Subject: Virgil C. Summer Nuclear Station (VCSNS) Units 2 and 3 Combined License Application (COLA) - Docket Numbers 52-027 and 52-028 Response to NRC Request for Additional Information (RAI) Letter No. 049

NRC RAI Letter No. 049 Dated June 19, 2009

SRP Section: 02.03.03 – Onsite Meteorological Measurements Programs

NRC RAI Number: 02.03.03.-1

Figure 2.3-202. 10-Meter Level Composite Wind Rose for the Units 2 and 3 Monitoring Program (January 1, 2007–December 31, 2008) — Annual

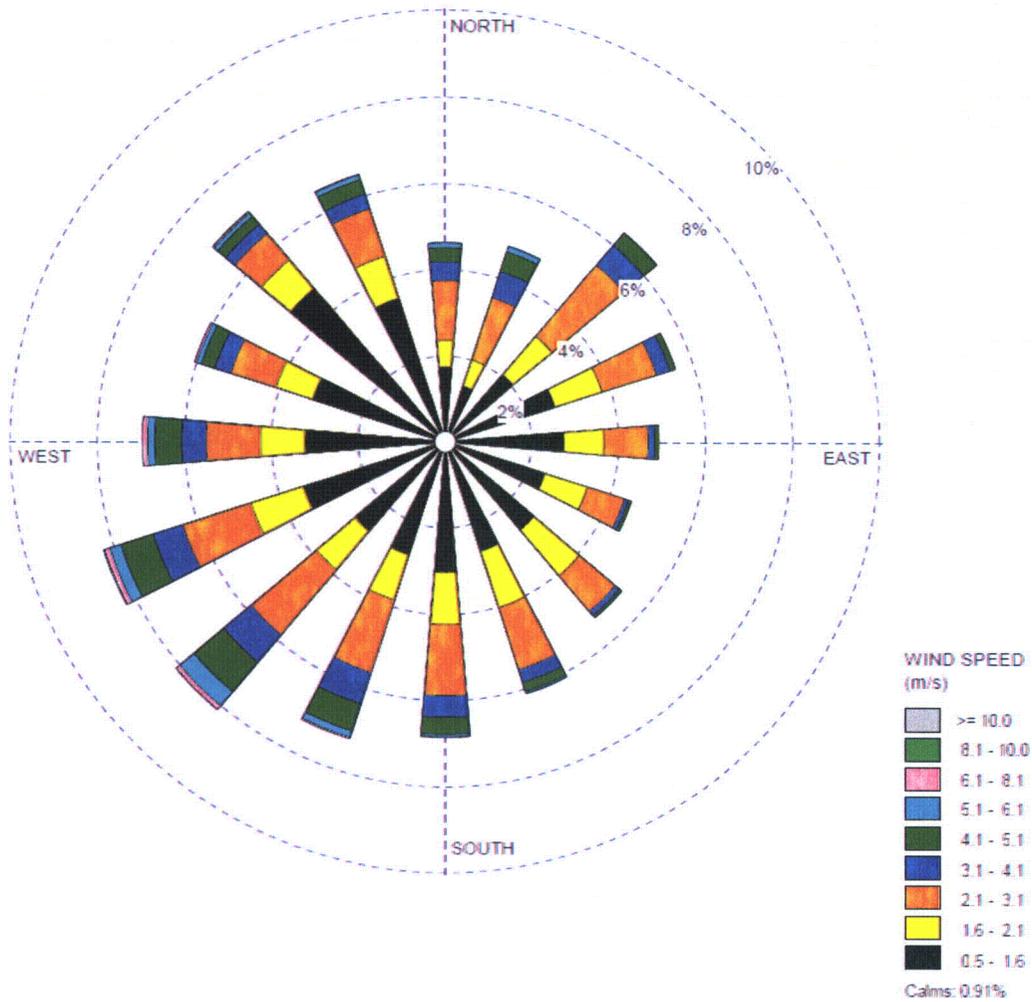
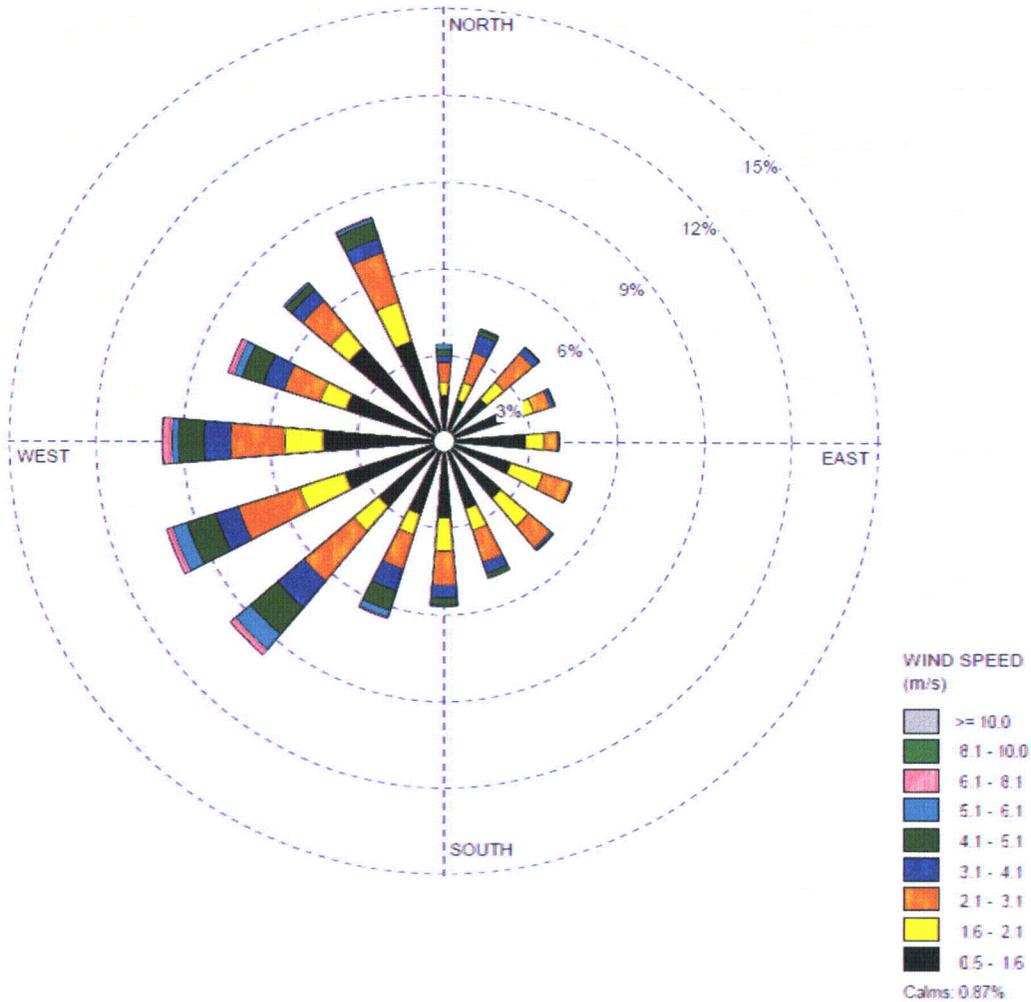
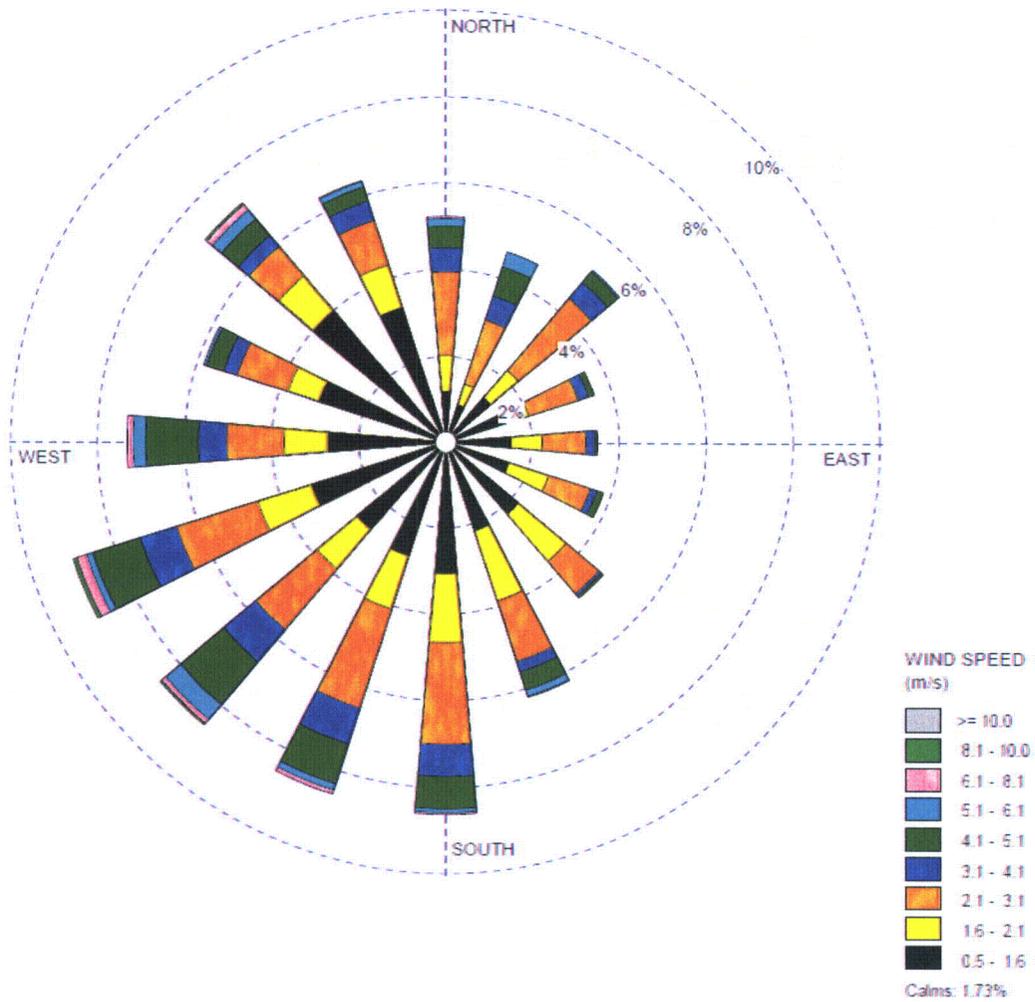
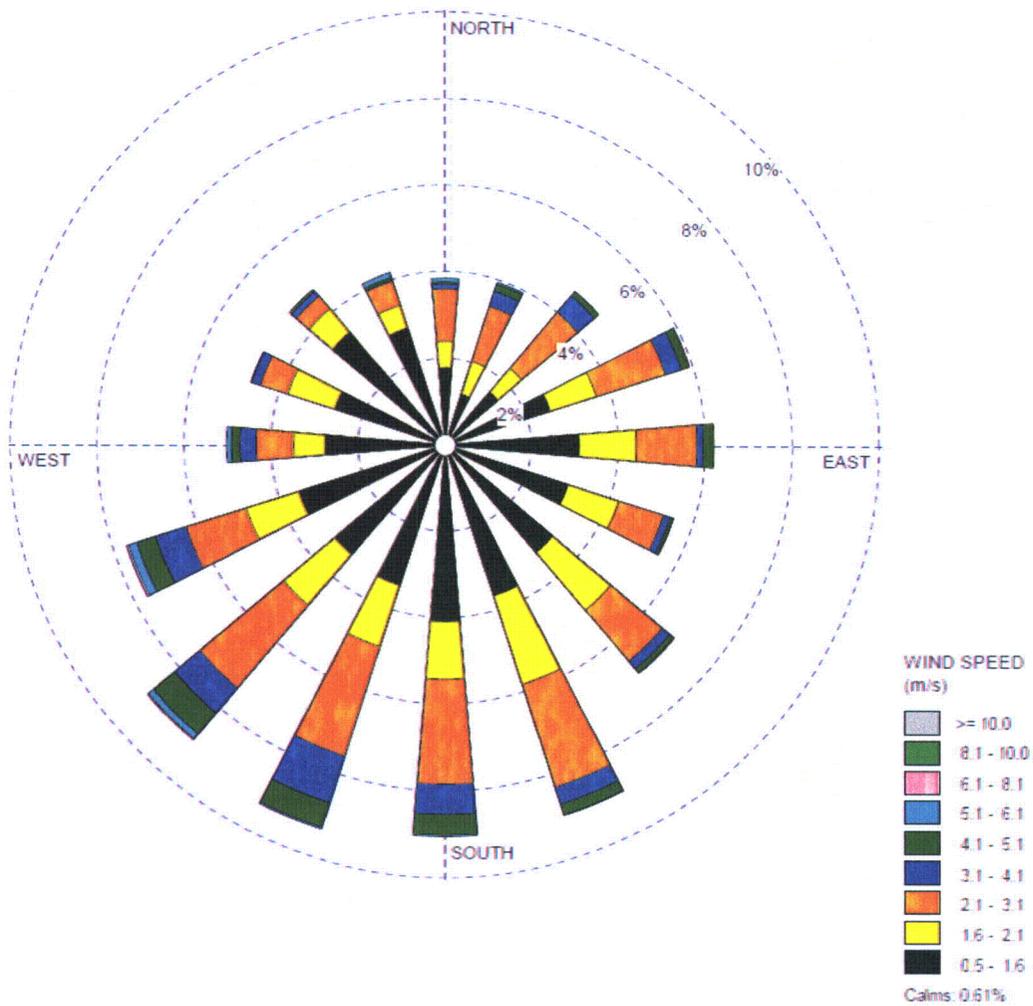
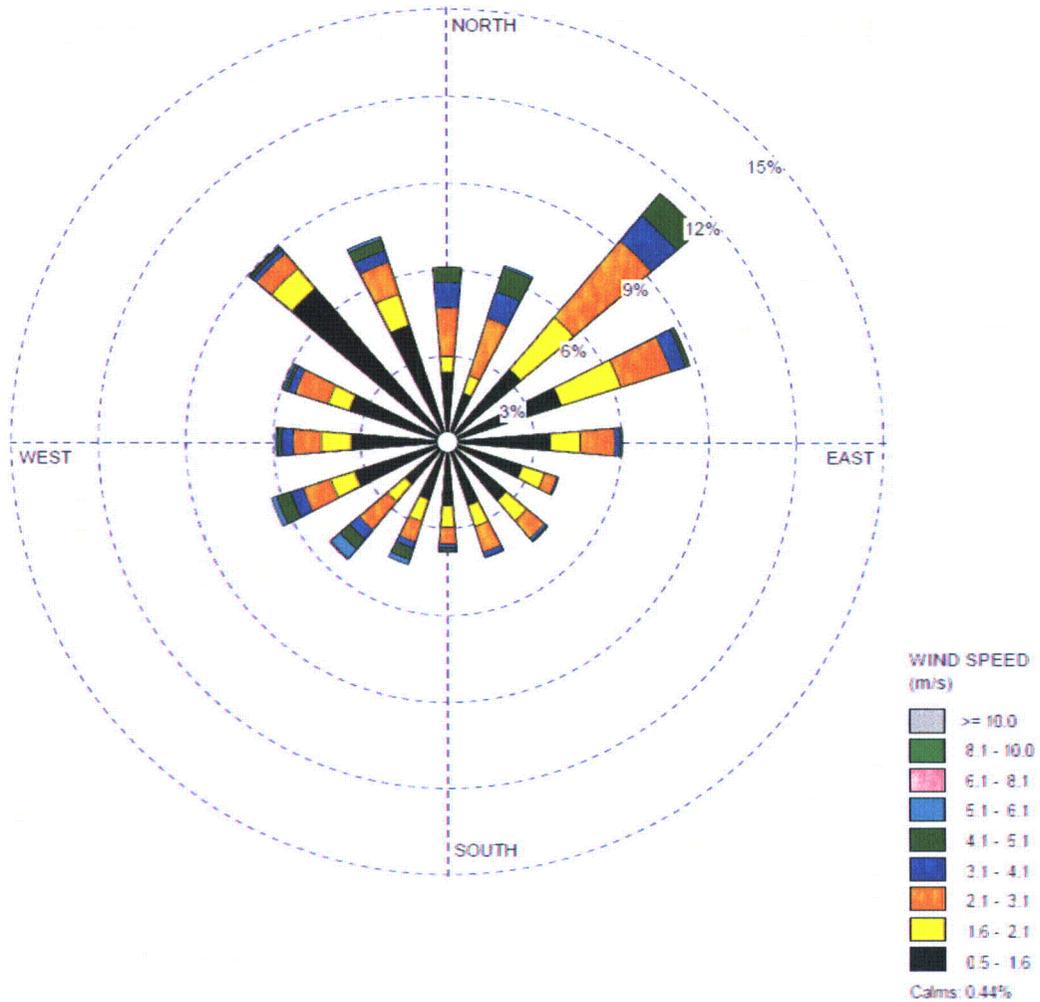
Revise the FSAR to contain the following based on the new, two year (Unit 2 and 3) meteorological data set:

- (1) Joint frequency distributions of wind speed, wind direction, and atmospheric stability for both measurement levels (10 and 60 meters), and annual and seasonal wind roses for both levels
- (2) Atmospheric dispersion and deposition factors presented in FSAR Sections 2.3.4 and 2.3.5.
Provide detailed user-provided information, including an electronic copy of the input and output files for the analyses using ARCON, PAVAN, and XOQDOQ, to allow the staff to perform its own confirmatory calculations.

Figures 2.3-202 through 2.3-206 present annual and seasonal wind rose plots (*i.e.*, graphical distributions of the direction from which the wind is blowing and wind speeds for each of sixteen, 22.5° compass sectors centered on north, north-northeast, northeast, etc.) for the 10-meter level based on measurements over the 2007 and 2008 annual cycles.

Seasonally, winds from the southwest quadrant predominate during the spring and summer months (see Figures 2.3-204 and 2.3-205). This is also the case during the winter, although westerly winds prevail and the relative frequency of west-northwest winds during this season is greater (see Figure 2.3-203) because of increased cold frontal passages. Winds from the northeast quadrant predominate during the autumn months (see Figure 2.3-206). ~~Plots of individual monthly wind roses at the 10-meter measurement level are presented in Figure 2.3-207.~~
